LEXINGTON-FAYETTE URBAN COUNTY GOVERNMENT CONTRACT CHANGE ORDER Page 1 of 11		Date: October 1, 2025 Project: Clays Mill Road Improvements, Section 1 Location: CMR - Waco to Harrodsburg Contract No. 17-2020 Original Contract Amt. \$10,683,653.39 Cumulative Amount of Previous Change Orders \$1,373,272.58 Percent Change - Previous Change Orders Total Contract Amount Prior to this Change Order \$12,056,925.97 Change Order No. 5 - Final	12.85%
To (Contractor): L-M Asphalt Partners, Ltd. dba ATS Construction 3009 Atkinson Ave, Suite 400, Lexington, KY 40509			
You are hereby requested to comply with the following changes from the contract plans and specification;			
Current Change Order

LEXINGTON-FAYETTE URBAN COUNTY GOVERNMENT CHANGE ORDER					DATE:	October 1, 2025	
					Change Order #:	5 - Final	
					CONTRACT #:	17-2020	
Project: Clays Mill Road Improvements, Section 1							
You are hereby requested to comply with the following changes from the contract plans and specifications;

**Clays Mill Road Improvements, Section 1
Change Order No.5 - Final
Reasons for Porposed Changes**

2626 & 2630

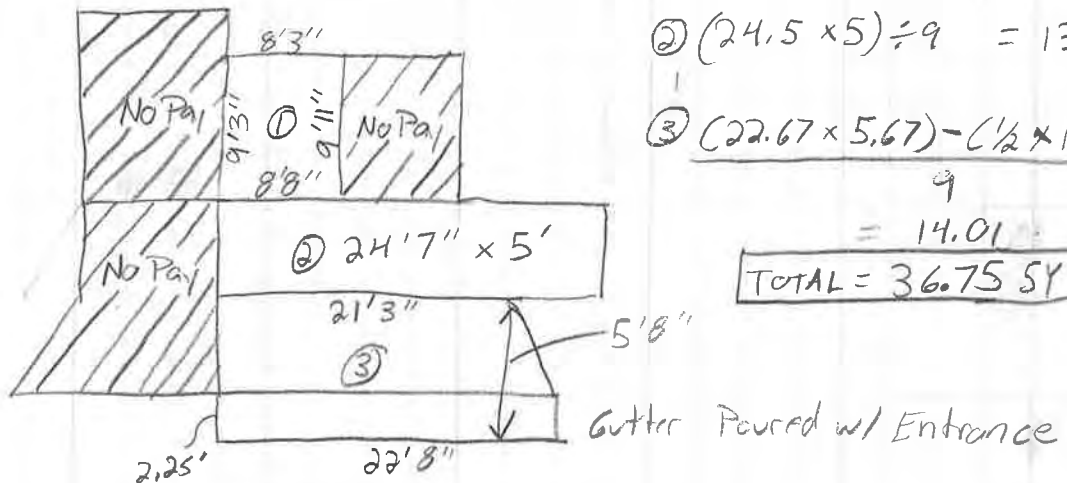
$$① (9.67 \times 8.5) \div 9 = 9.13 \text{ SY}$$

$$② (24.5 \times 5) \div 9 = 13.61 \text{ SY}$$

$$③ \frac{(22.67 \times 5.67) - (\frac{1}{2} \times 1.42 \times 3.42)}{9}$$

2779

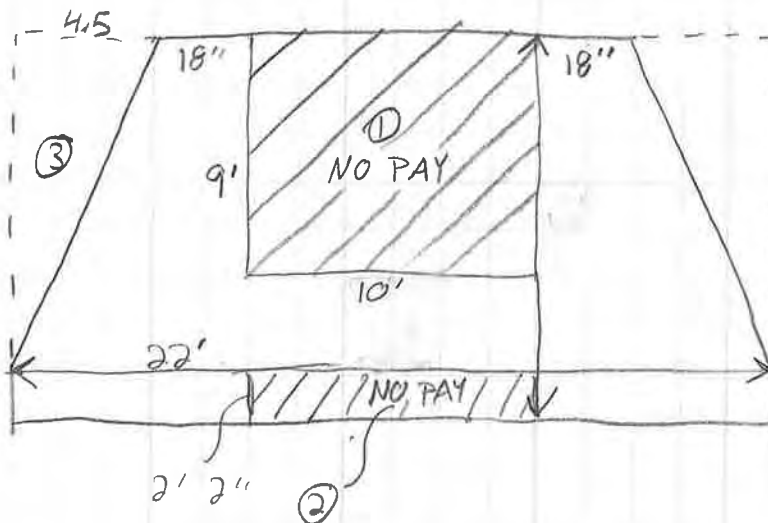
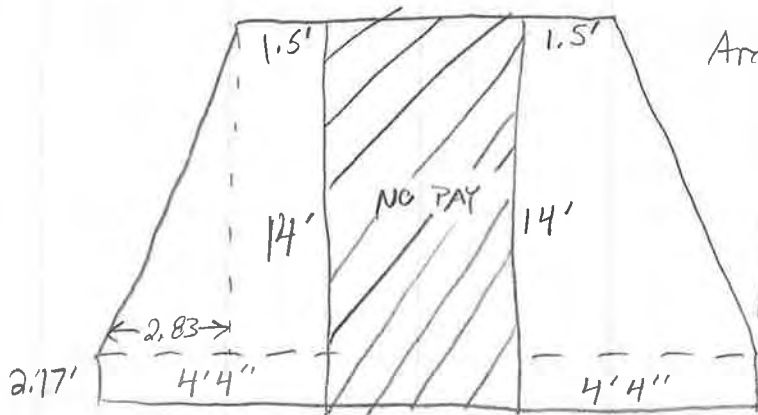
$$① 9 \times 10 = 90 \text{ SF}$$

$$② 10 \times 2.17 = 21.75 \text{ SF}$$

$$③ \frac{1}{2} [4.5 \times 12.83] = 28.88 \text{ SF}$$

$$\text{Area} = [(22 \times 15) - ① - ② - ③] \div 9 = [330 - 90 - 21.75 - 28.88] \div 9$$

$$\boxed{TOTAL = 9.73 SY}$$

MITCHELL AVE

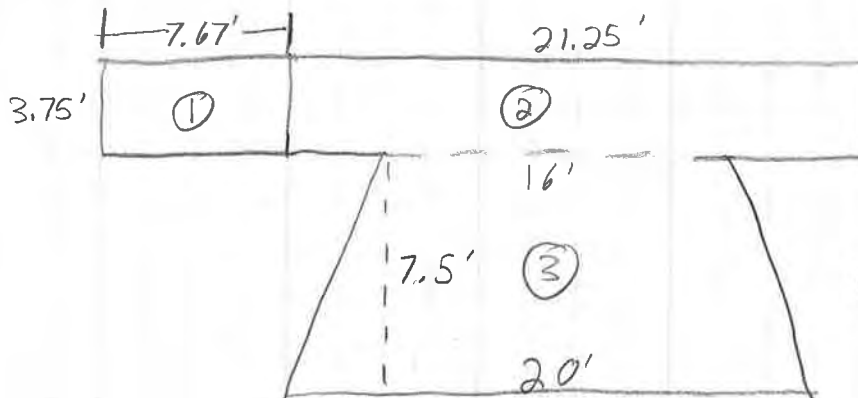
$$\textcircled{1} \quad 7.67 \times 3.75 / 9 = 3.20 SY$$

$$\textcircled{3} \quad \frac{\frac{1}{2} (16 + 20) \cdot 7.5}{9} = 15 SY$$

$$\boxed{TOTAL = 27.05 SY}$$

Alignment – (4) PROFILE

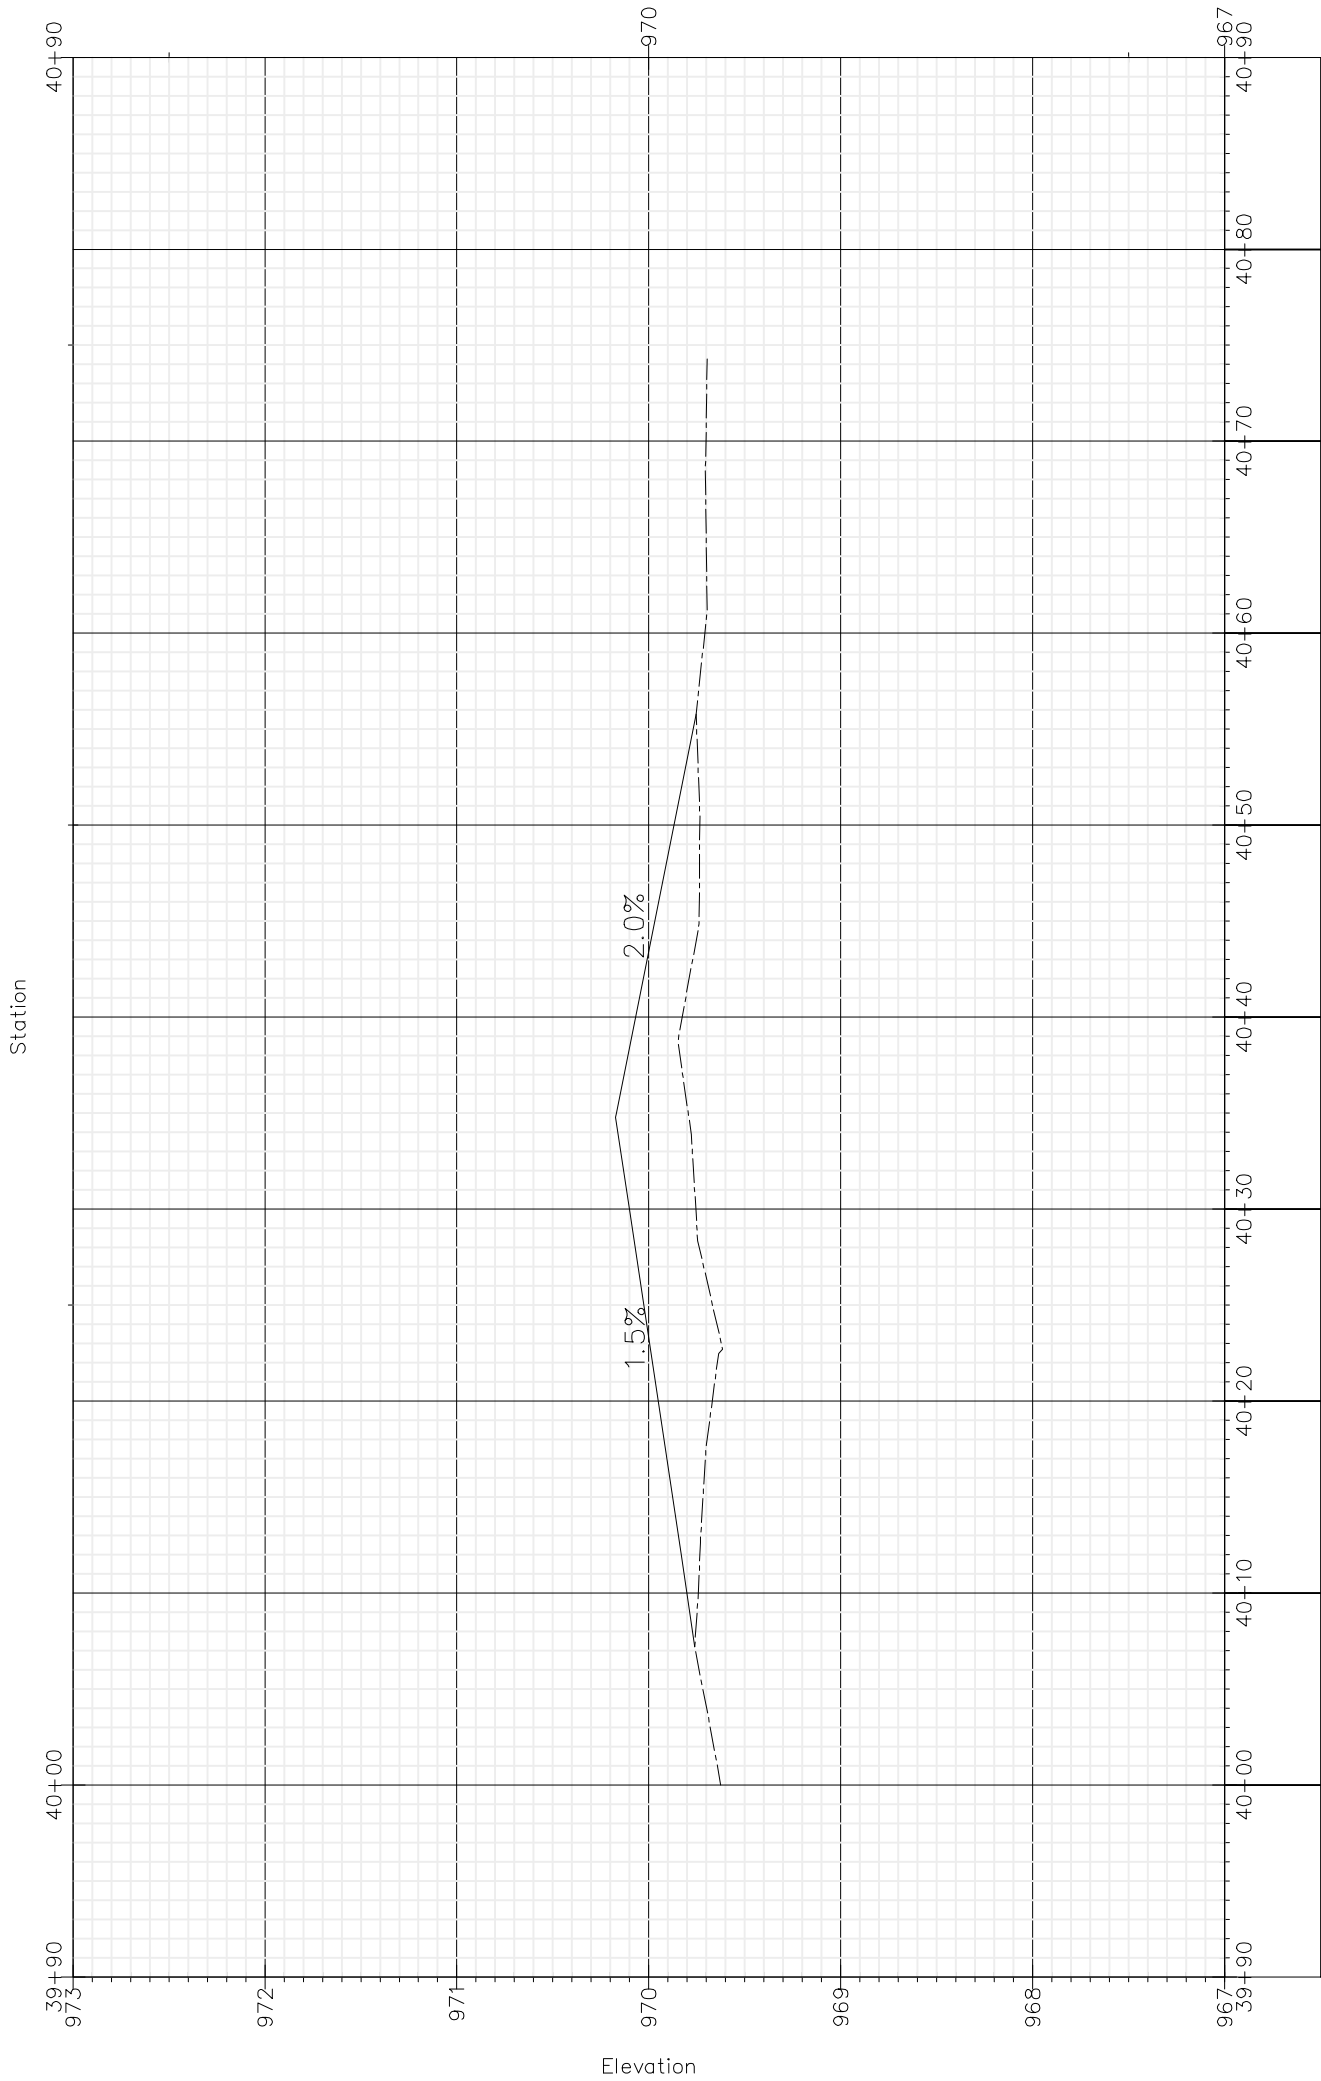
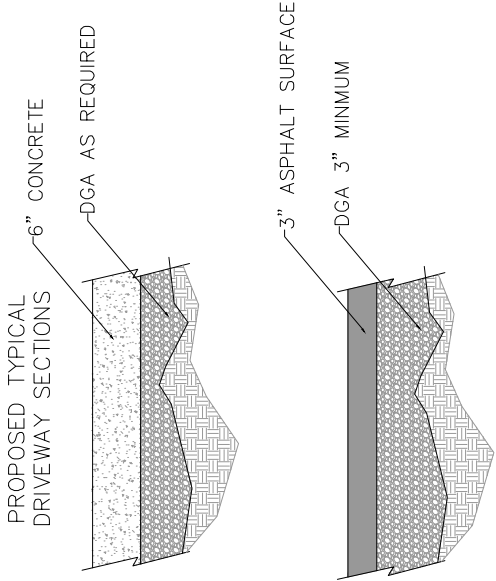
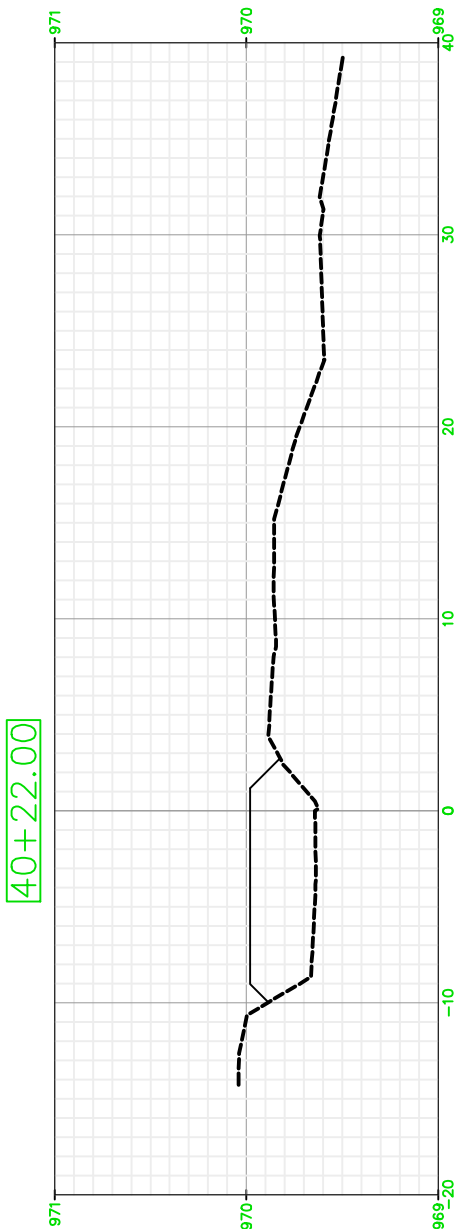
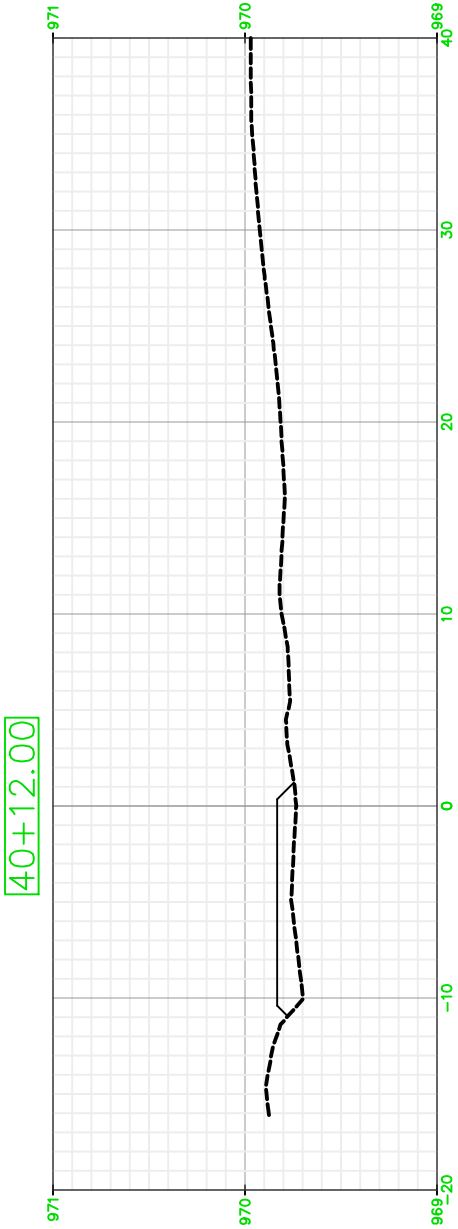
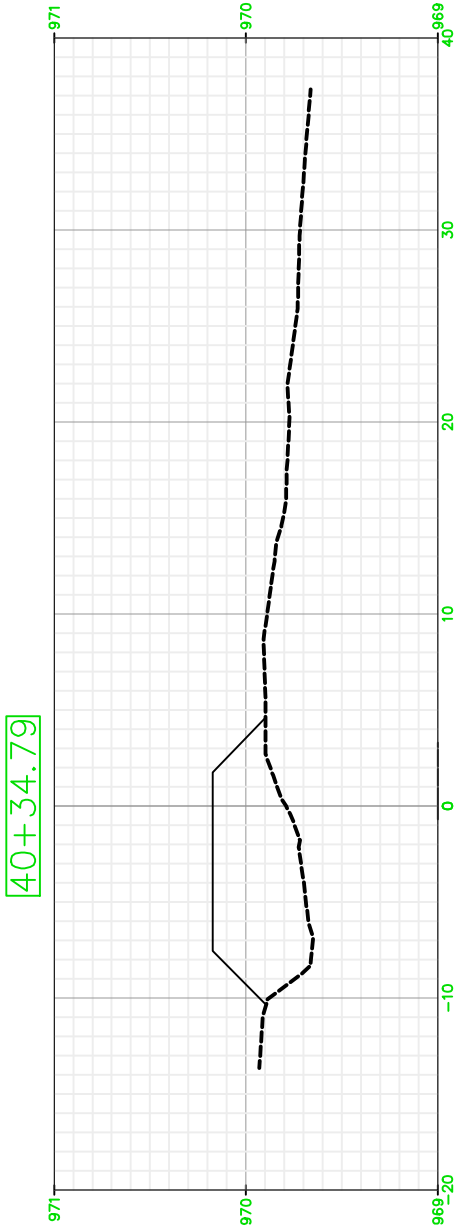
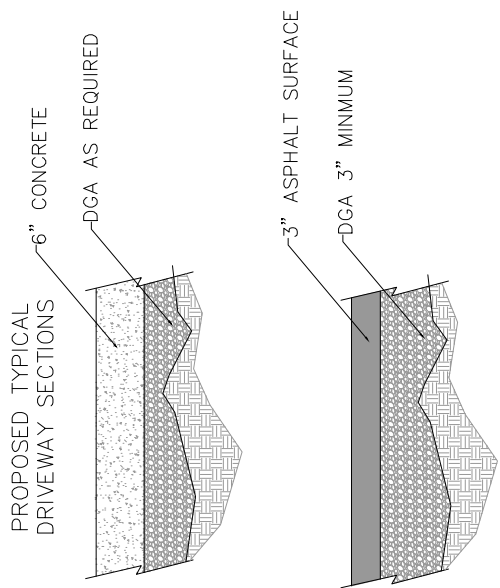
At the request of LFUCG, ATS Construction proposes the following price to remove, regrade, and repave the driveway at 1811 Clays Mill Road per the attached drawing provided by LFUCG.

1) Manhole MH-C5 is the trunkline sewer (in mainline pavement.)
 2) Elevations are conflated w/ MH-C6

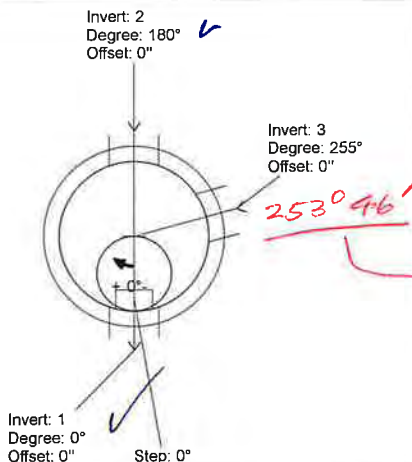
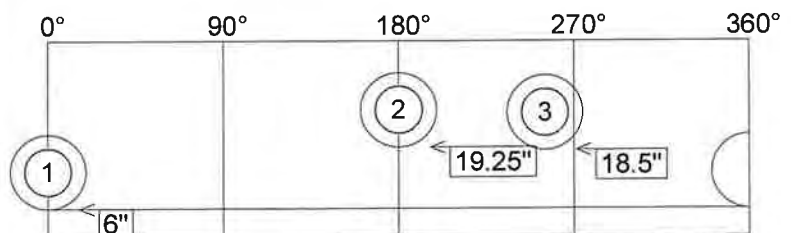
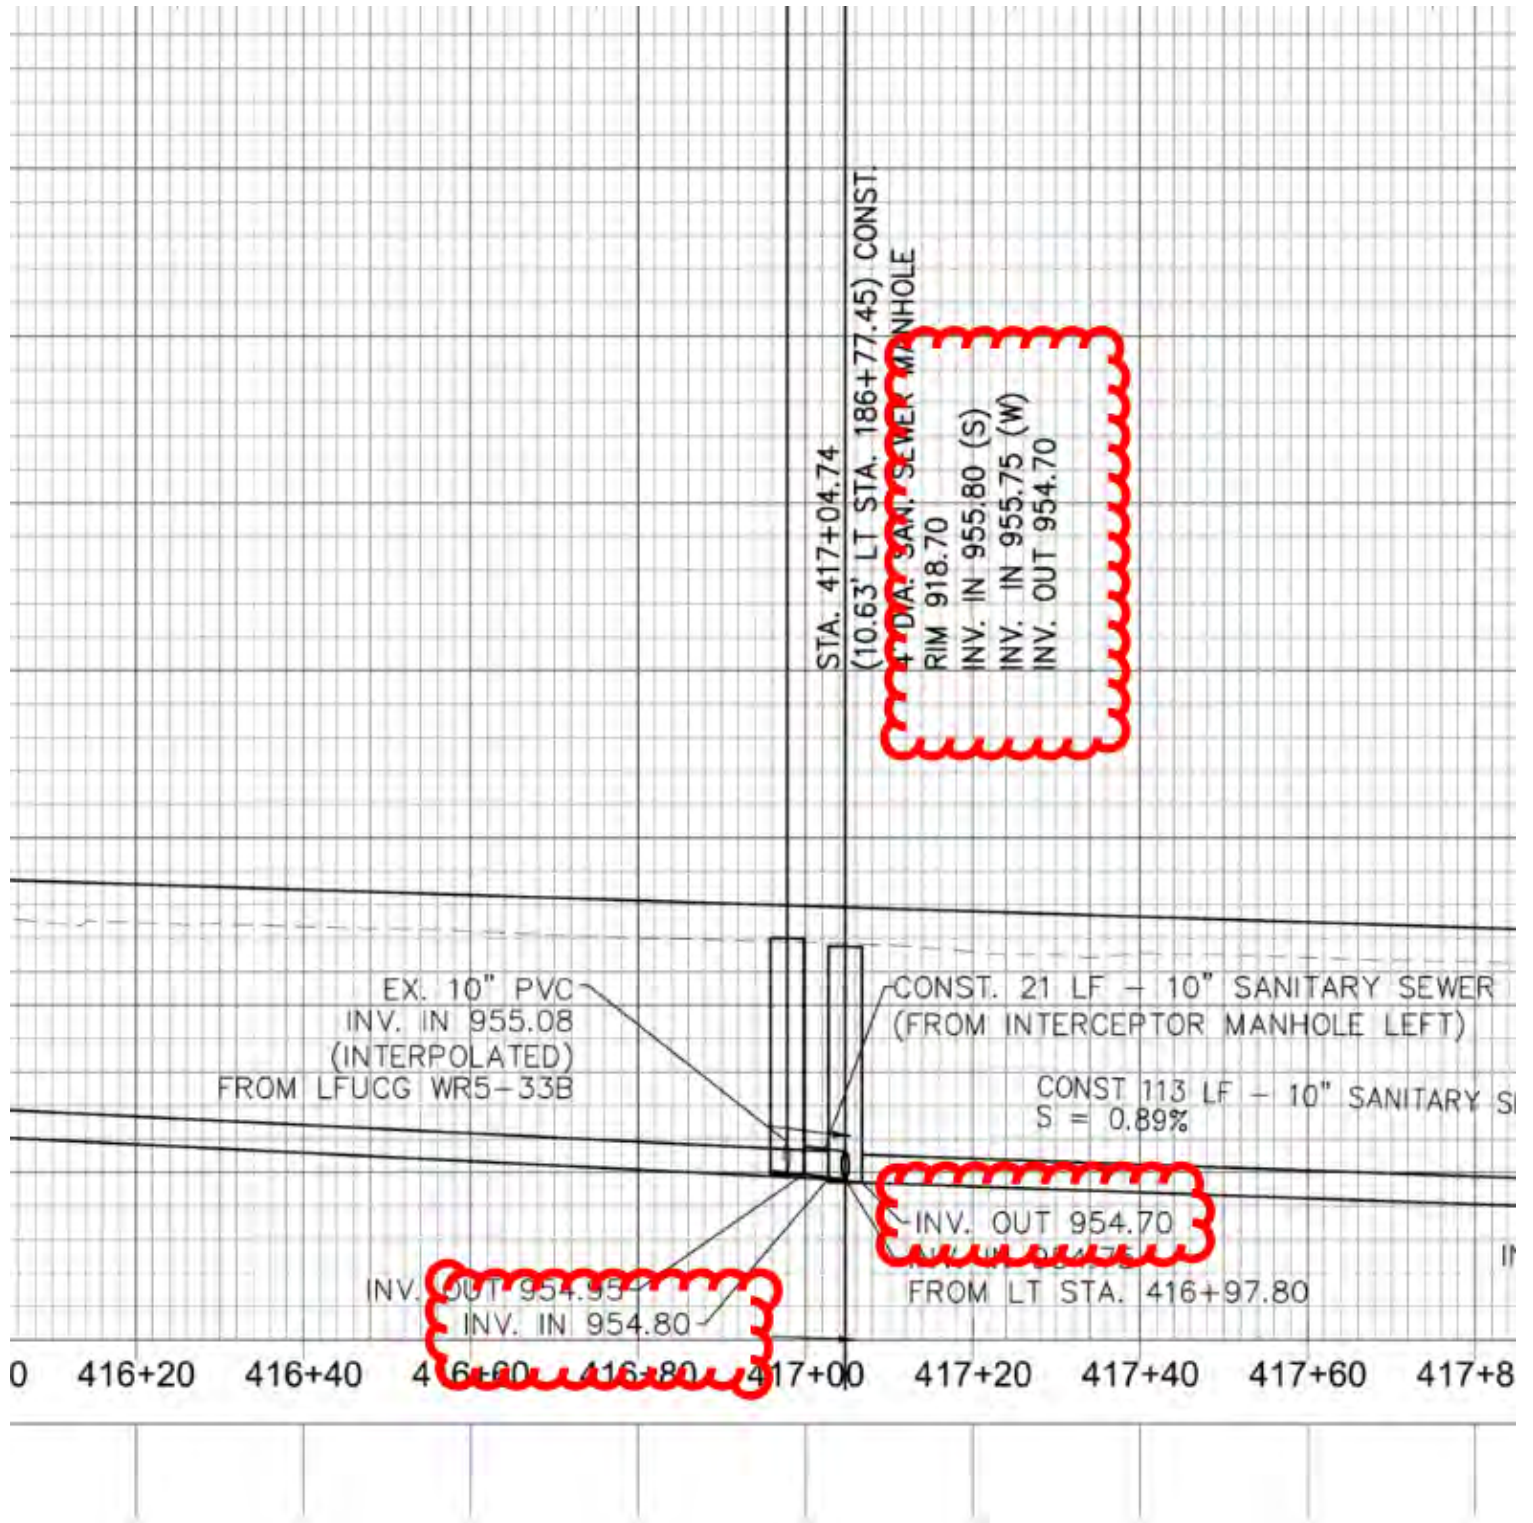
Per the revised sanitary sewer plan, manhole C6 was supposed to tie to C5 with a short connection. Existing elevations of the PVC Lateral were lower than the proposed C5 and trunk line. Modifications were made to C6 to run the outlet line adjacent to the storm sewer and tie to the existing Sanitary Manhole Lt Sta 188+05. The Lateral from C5 was capped off.
